RANDOX
Urgent Field Safety Notice

Complaint Reference: REC473

Action Type: Device Modification

Fig. 1 Patient correlation using original assigned calibrator values and realigned calibrator values on Siemens ADVIA 1800

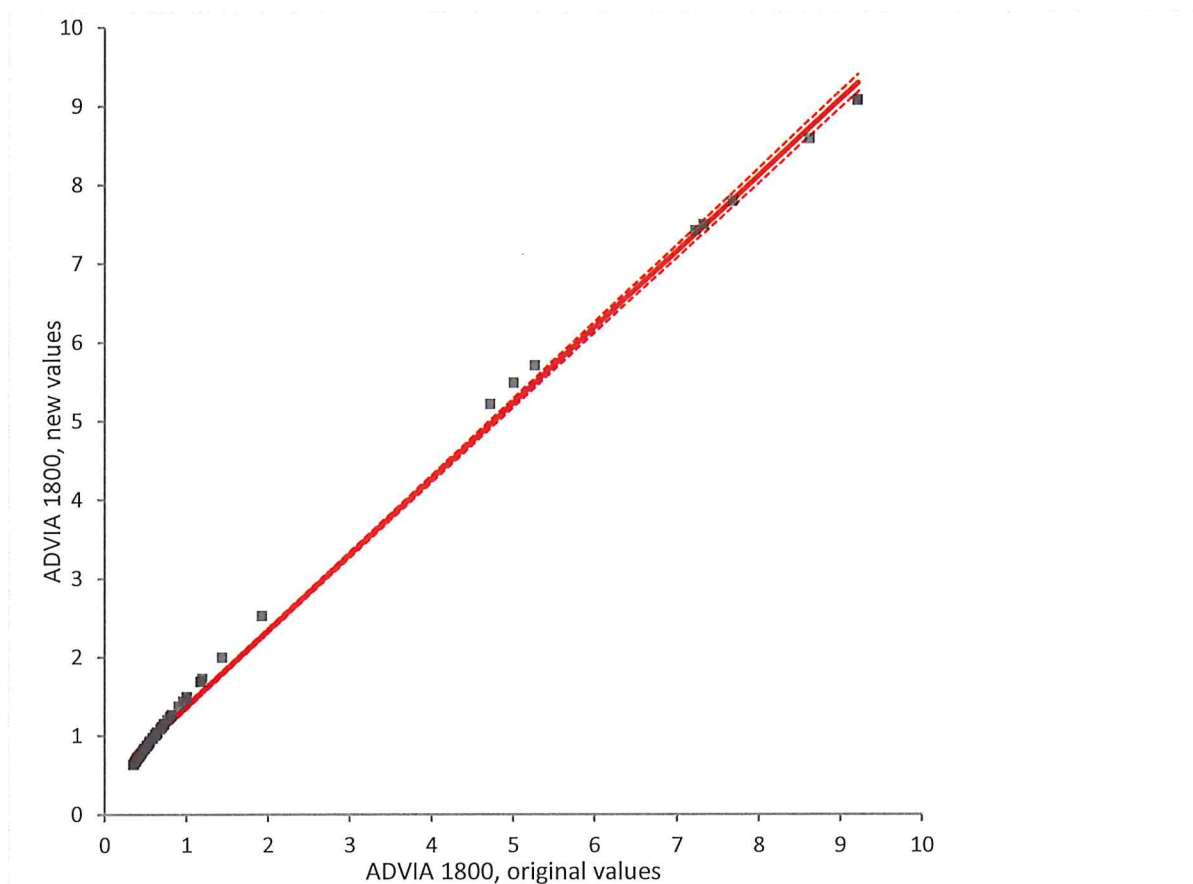
Randox have reviewed the standardisation for Soluble Transferrin Receptor (sTfR) as per the labelling claim and have realigned the sTfR Immunoturbidimetric method to the WHO reference material NIBSC code 07/202. As a result the Calibrator and Control batches listed in the table above have been reassigned. Patient values will increase with the new calibrator values and the shift is more pronounced within the normal range (0.65mg/dl to 1.88mg/dl). See patient correlation below (Fig. 1).

- Refer to the attached IFUs for updated calibrator values and control targets and ranges. These can also be found on www.randox.com.
